P 517440-B
 A REPAIR

**ON-SITE SEWAGE DISPOSAL SYSTEM
 HOWARD COUNTY HEALTH DEPARTMENT
 BUREAU OF ENVIRONMENTAL HEALTH**

ADDRESS: 7441 Cherry Tree Drive PROPERTY OWNER: A Nayab Siddiqui

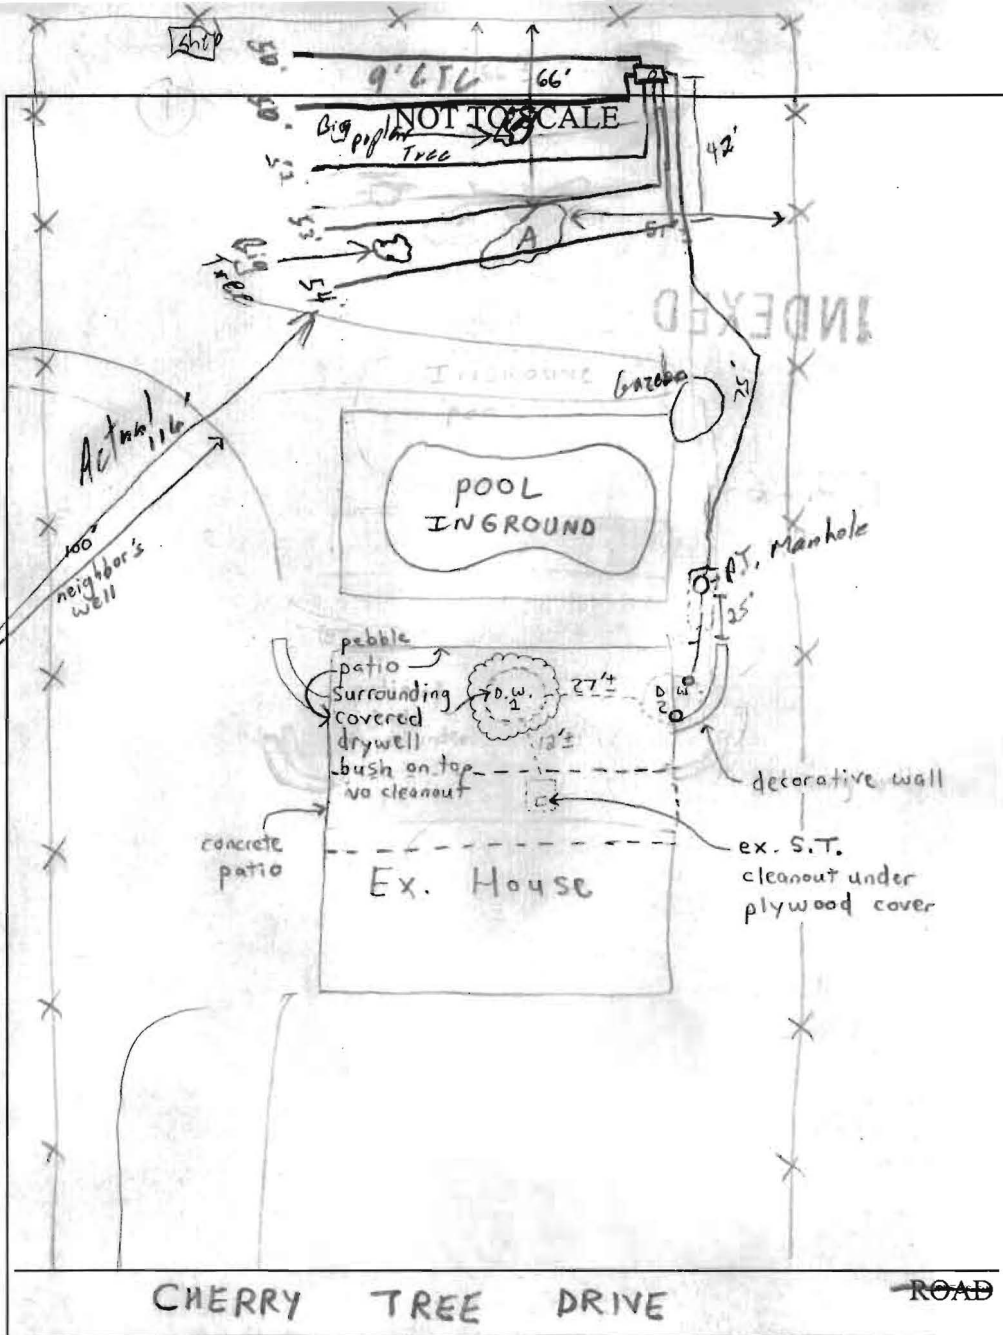
PRE-CONSTRUCTION 9/4/02 - EXISTING S.T. & DRYWELLS UNDER PATIO'S, BEST REPAIR OPTION IS TO INSTALL Pump TANK OFF OF D.W. #2 & PUMP TO REAR OF LOT NEAR PERC HOLE (A) INSTALL PER DISCUSSED - (SRK)

11/3/02 2 trenches installed, OK to cover (SO) 11/20/02 Trenches finished, OK to cover. Edge of 2nd D.W. uncovered. Observed P.T. # got spec sheet (SO) 11-21-02 18" from #2 D.W. c/o to beginning of S.T. Inlet @ 4' into tank. Will set tank today, fill w/ water & fill around it to prevent floating. Fogles will call insp for tomorrow.

Note the pool was installed w/o permit as well as concrete patio over the existing drywells (RN) 11/22/02 Pump & Alarm OK
